Zone (paddle) valve replacement Information 2017

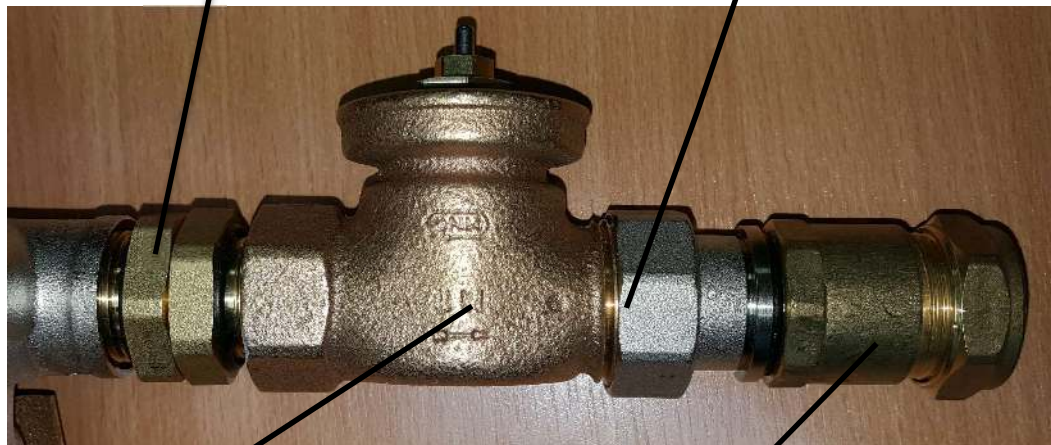
Existing valve with head removed

Reuse this fitting
($\frac{3}{4}$ " M x $\frac{3}{4}$ " M BSP)
PPA0169

1" F X $\frac{3}{4}$ " M SOFT SEAL FITTING
PPA0111

$\frac{3}{4}$ " hi flow valve
VAP0017

Replacement valve

22MM X $\frac{3}{4}$ " F BSP CONEX
CBF0027

When carrying out this change over, the replacement return valve assembly (SUB0040 or SUB0050) can be fitted respectively with a 2 wire (CON0043) or 4 wire (CON0074) actuator for either a multizone or single zone manifold. Please ensure you reuse the PPA0169 on both installations.
